DESIGN DRAWING FOR DCR 1672

WISCONSIN PUBLIC SERVICE CORPORATION
KEWAUNEE NUCLEAR POWER PLANT - UNIT NO. 1
CARLTON, KEWAUNEE COUNTY, WISCONSIN

INTEGRATED LOGIC DIAGRAM TURBINE SYSTEM

SCHEMATIC DIAGRAM - MOTOR VALVE MOTOR 1-165

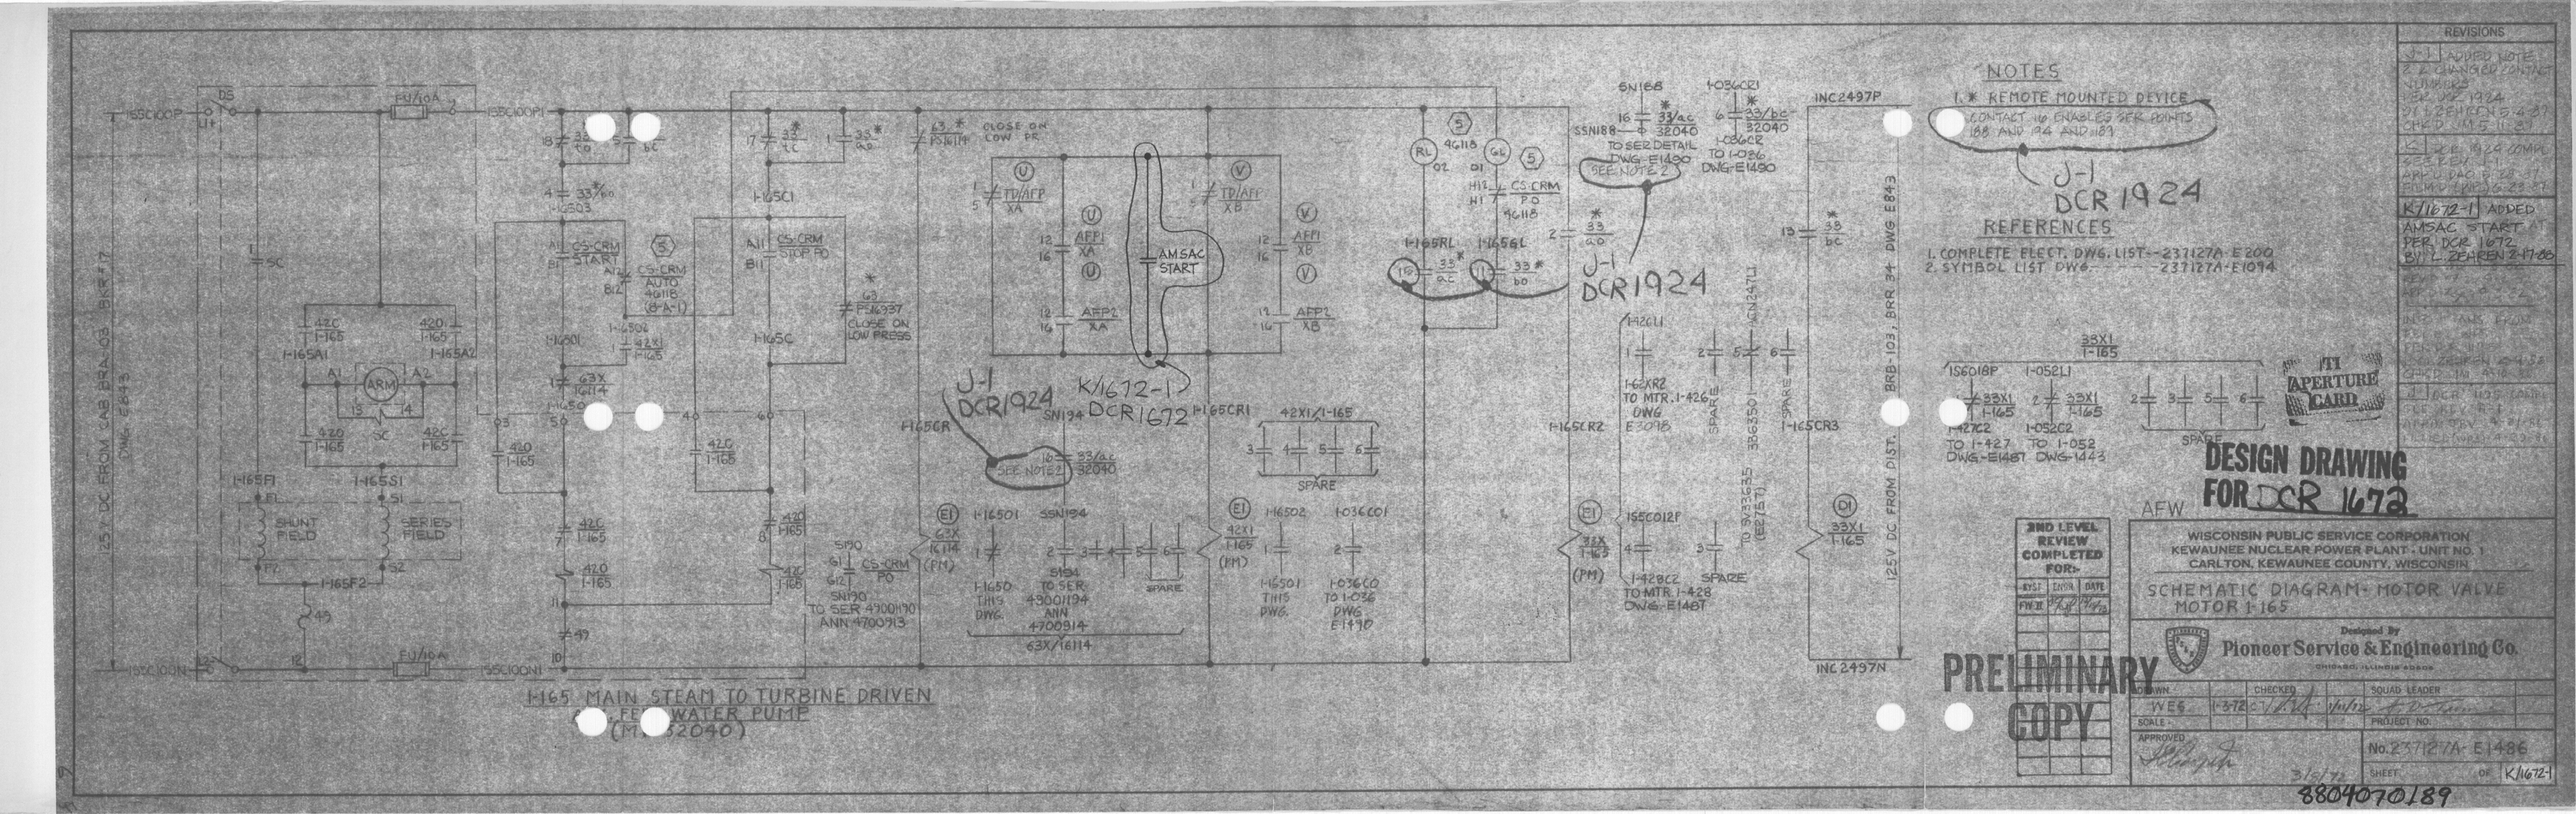
[illegible] AMSAC
	[illegible]
	[illegible]
	ZERO [illegible]

D ADDED SIGNALS FROM MS ISOLATION VLVS TO THE TURB AUTO STOP TRIP S/S. (DCM-188) DWN: TY.MOY 4-30-74 CHKD: MAB 5-2-74 APPD: WJK 5-3-74 FILMED: 5-6-74

E-1 UDS PROJ. #380207 DCR-1008 REMOVED SINGLE CHANNEL OVERSPEED TRIP SYSTEM. ADDED REDUNDANT CHANNEL OVERSPEED TRIP SYSTEM, DELETED ALARM A47003243 & SER 49001374. REVISED ALARMS A47003233, A47001453, & SER 49001385. REMOVED NOTES 4, 5, & 7. ADDED NOTE 8, DWN: AC.C. 3-2-82 CHKD: R.S. 3-15-82 APPD: DE.COV 3-19-82

G-1 DCR 1008 ADDED ANNUNCIATOR (A47003233) ACTIVATION FOR OVERSPEED TRIP RELAY ACTIVATION BY: KTB 9-2-84 CHK'D: JM 9-7-84

H-1 DCR 1008 "AS BUILTS" AS WIRED DWG. NO. 237127A-E2057 CHANGES: 2 ADDED, 2 DELETED, 2 CHANGED, 1 MOVED DWN: KTB 11-2-84 CHK'D: JM 11-5-84 JJCC/JM X-Connect SEE REV. H-1 APP'D: PED 11-13-84 FILMED (APT) 11-27-84

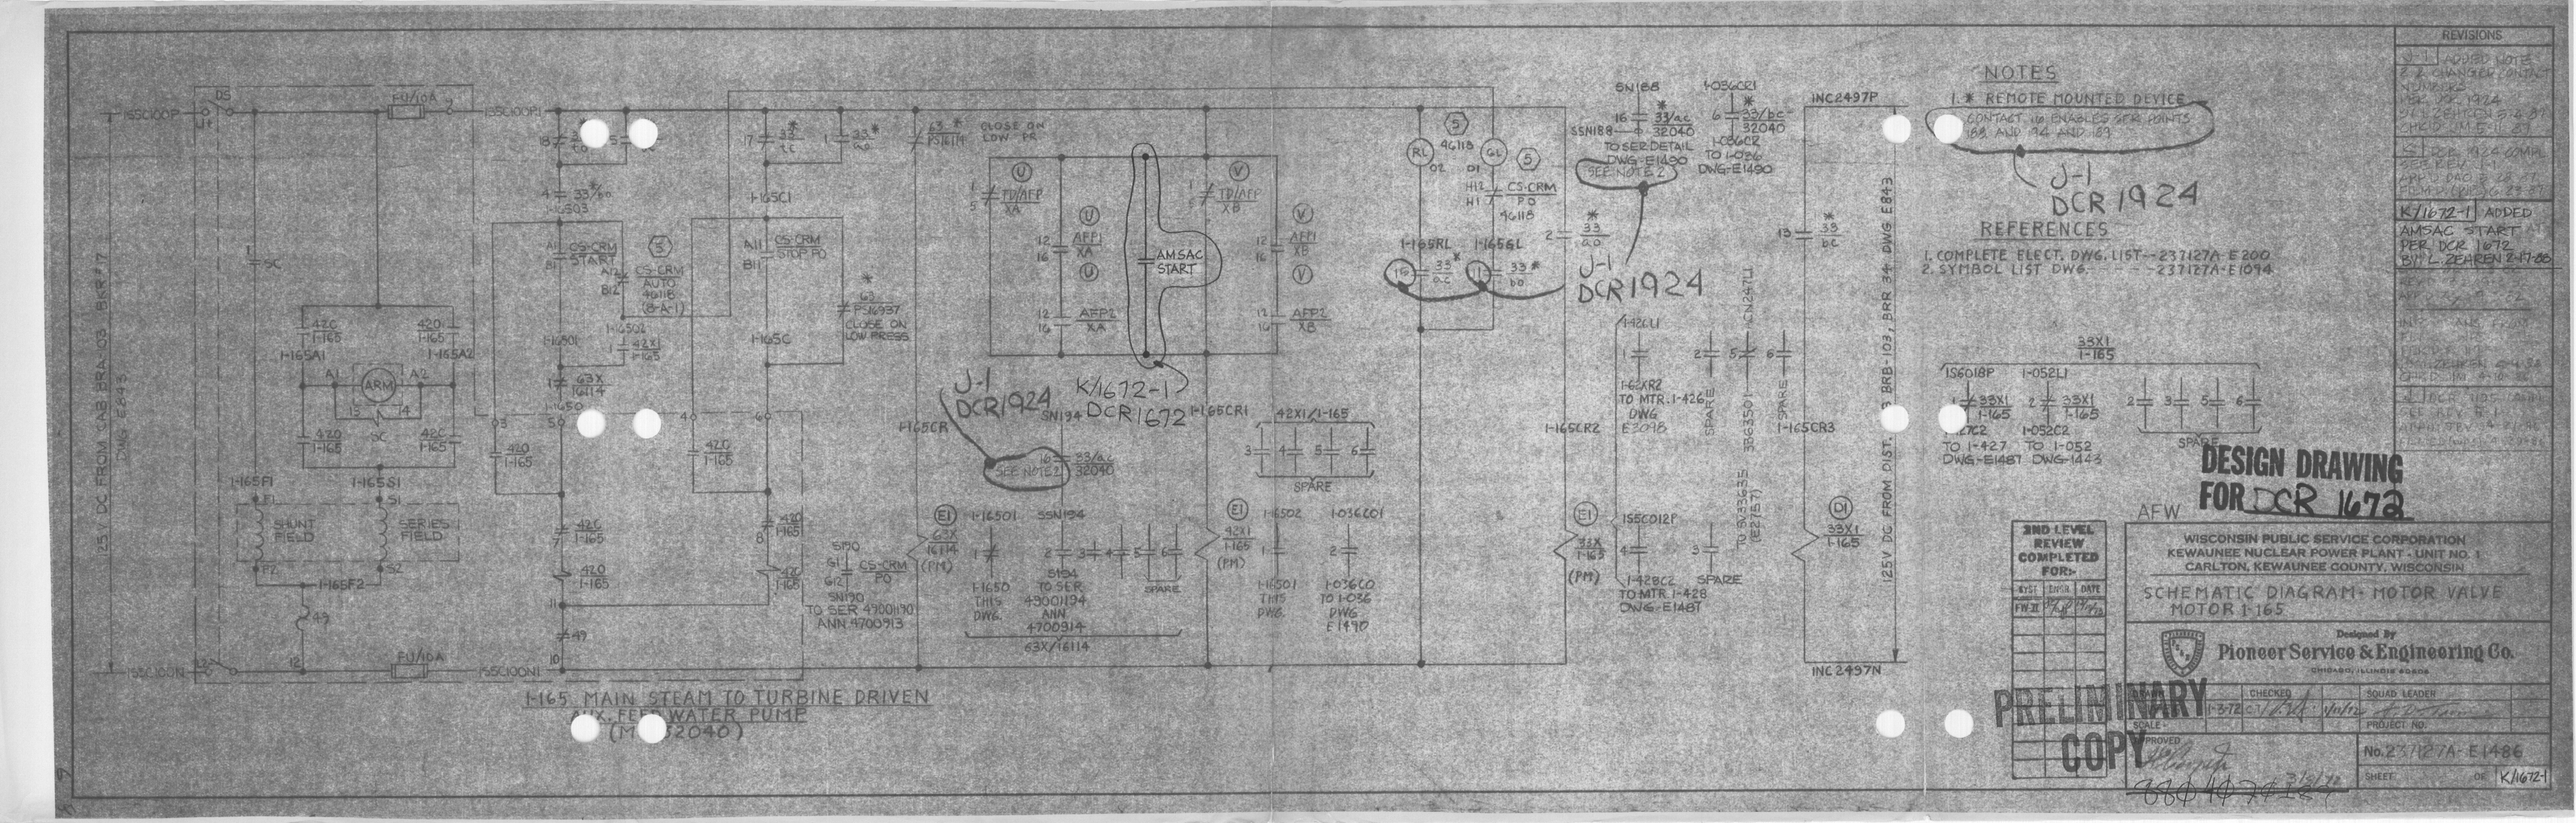
J-1	ADDED NOTE 1, 2 CHANGED CONTACT NUMBER PER DCR 1924 DRAWN BY J.F. ZEHREN 2-14-80 CHKD. J.M. SILL 2-19-80
K/1672-1	ADDED AMSAC START PER DCR 1672 BY L. ZEHREN 2-17-80

SHEET
OF
K/1672-1
PRELIMINARY COPY
REVISIONS
J-1 ADDED NOTE 2 & CHANGED CONTACT NUMBERS PER DCR 1924 BY L. ZEHREN 5-2-89
K/1672-1 ADDED AMSAC START PER DCR 1672 BY L. ZEHREN 2-17-88
